Conceptual Review Agenda

Schedule for 03/28/16 to 03/28/16

1906 Laporte Ave Single-family Detached

CONCEPTUAL REVIEW: APPLICATION

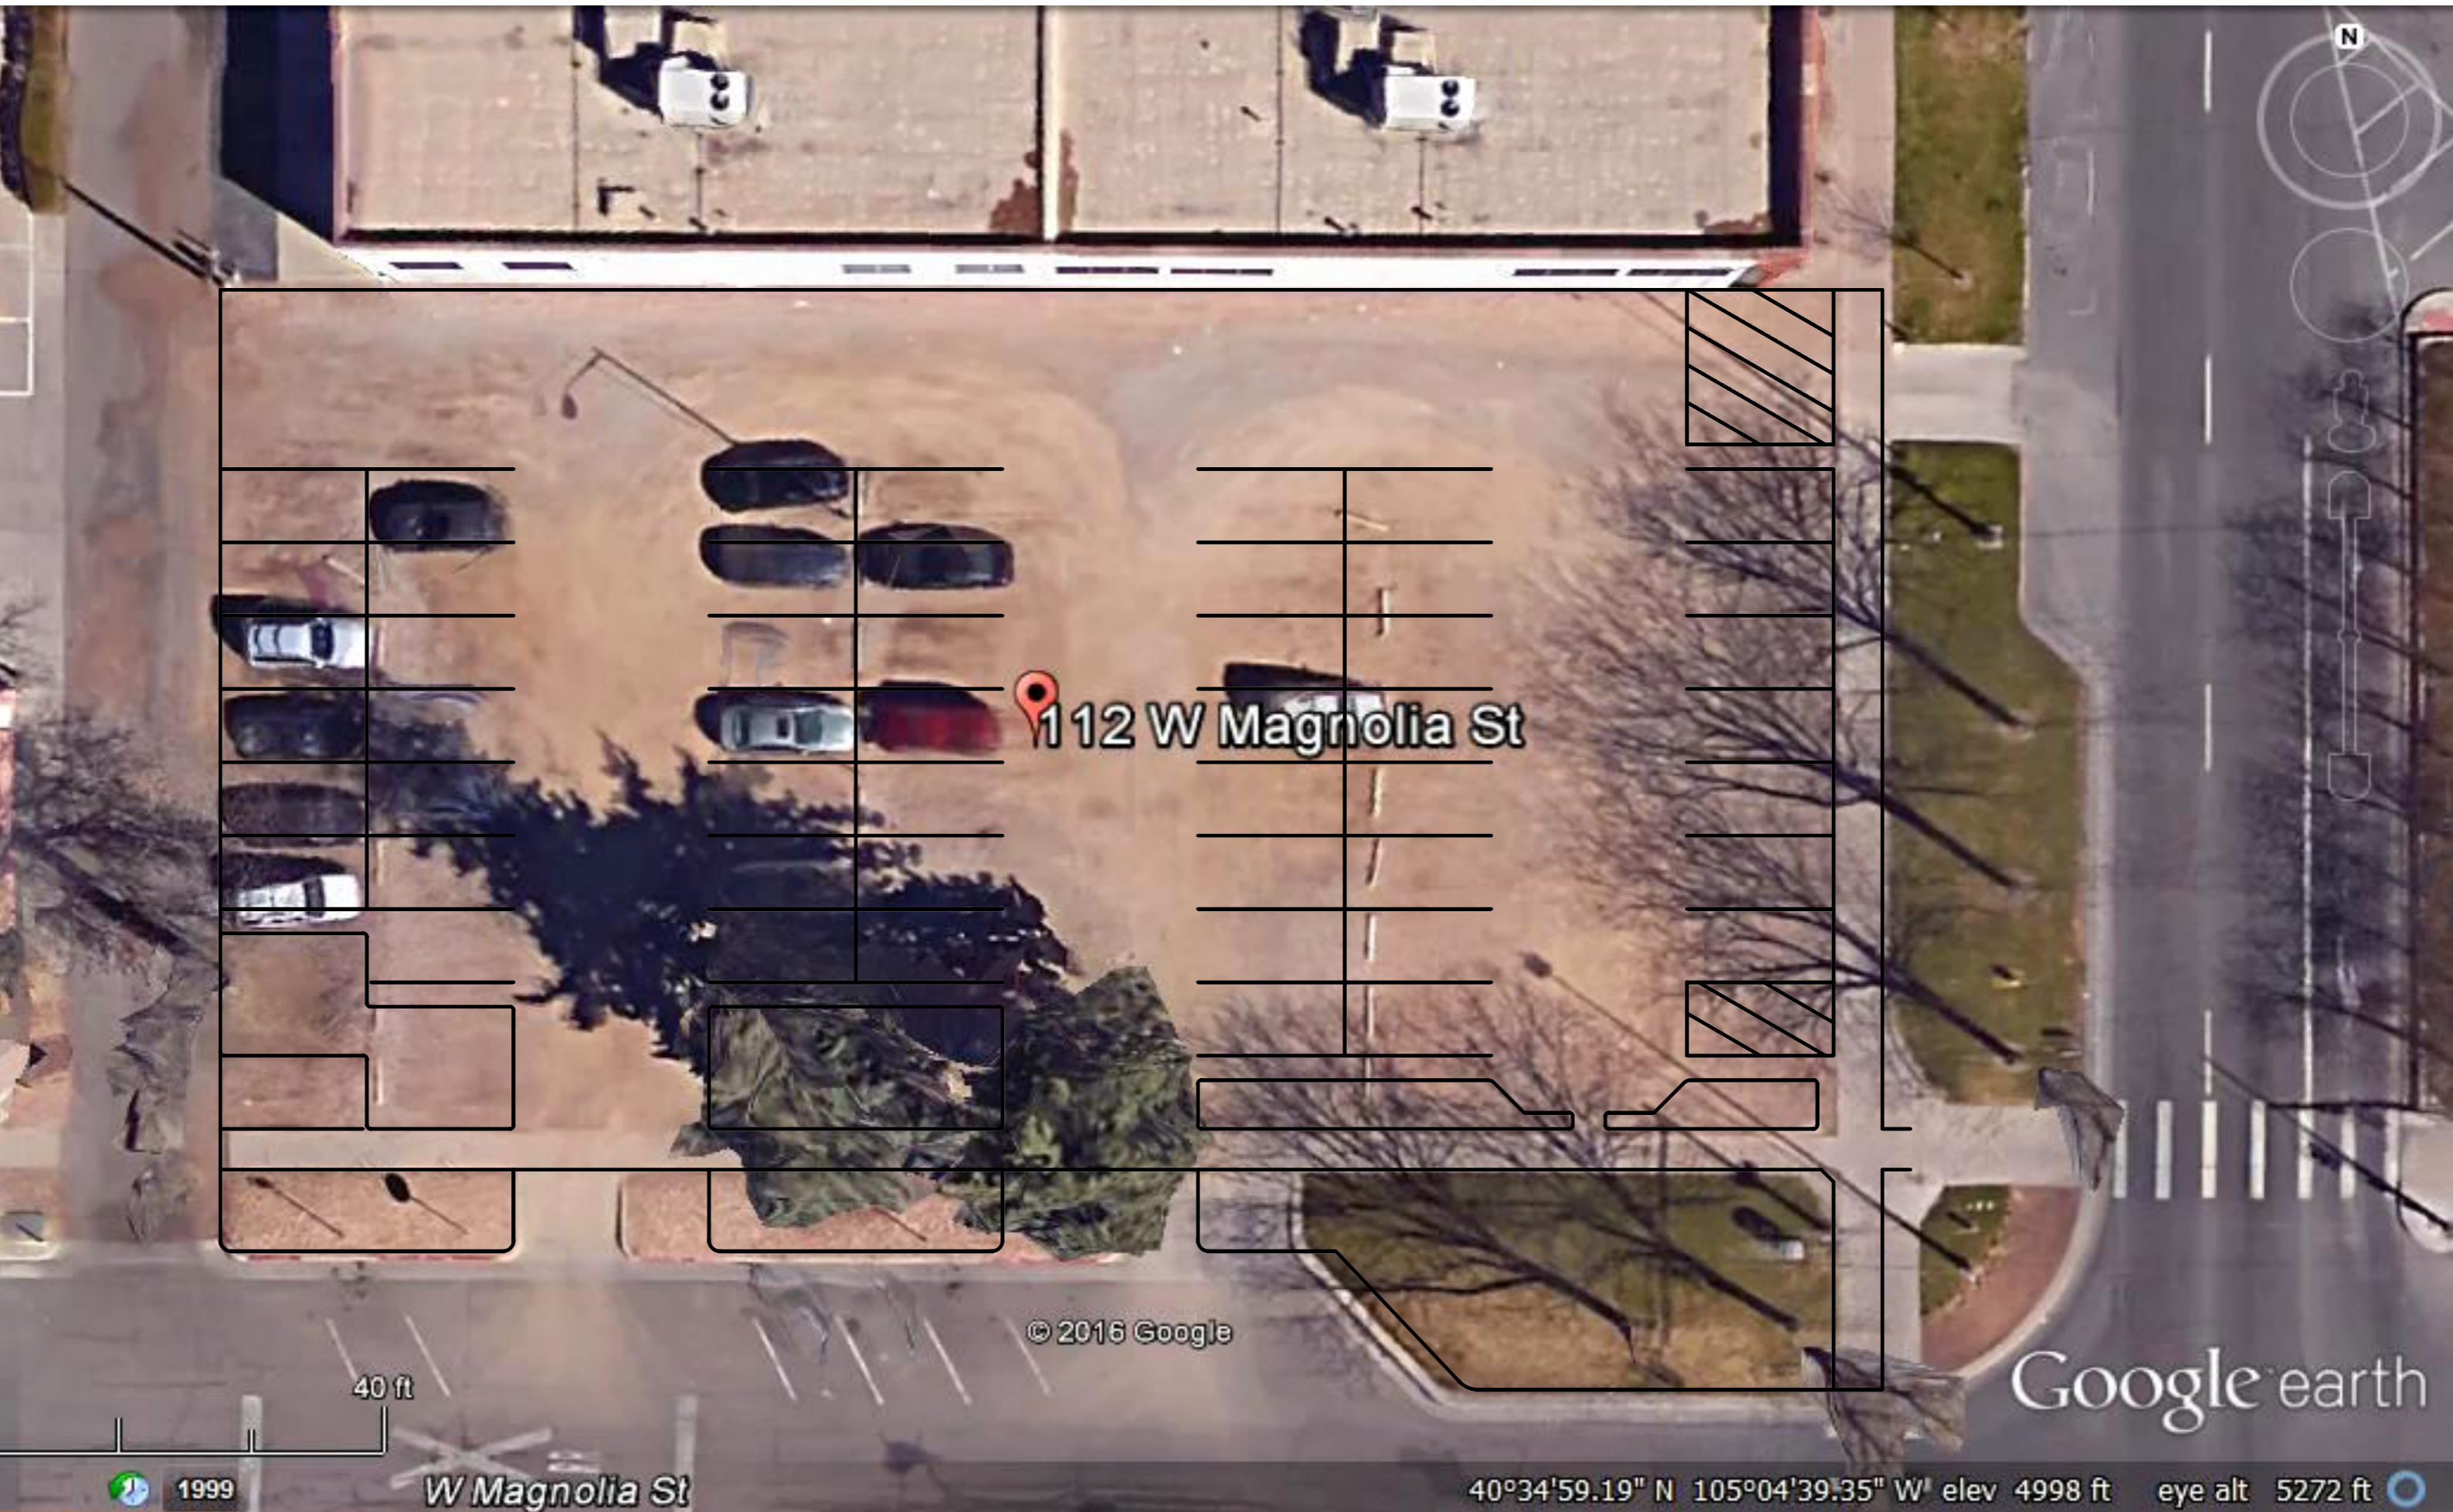
3. Can one (or maybe even both?) of the accesses on Magnolia be closed? With an alley access and perhaps one access on Magnolia that would seem to provide adequate access, and allow for additional on-street parking to be striped.

6. The parking stalls shown on the east of the site will need wheel stops so that the front end of the vehicle is at least 2' behind the sidewalk.
7. This project is responsible for dedicating any right-of-way and easements that are necessary or required by the City for this project. This shall including the standard utility easements that are to be provided behind the right-of-way (15 foot along an arterial, 8 foot along an alley, and 9 foot along all other street classifications). ROW may be needed to provide the minimum 7' sidewalks required for Downtown.

12. LCUASS parking setbacks (Figure 19-6) apply and will need to be followed depending on parking design. It appears that the eastern access on Magnolia Street may not meet standards.

13. LCUASS intersection spacing requirements apply. Please verify that the two driveways along Magnolia meet minimum driveway spacing requirements. Also, verify that the minimum distance between the eastern driveway and College Avenue is met.

14. With the driveway location changes, it appears that an on street parking spot may need to be removed. Please work with Parking Services to verify that this will be allowed.
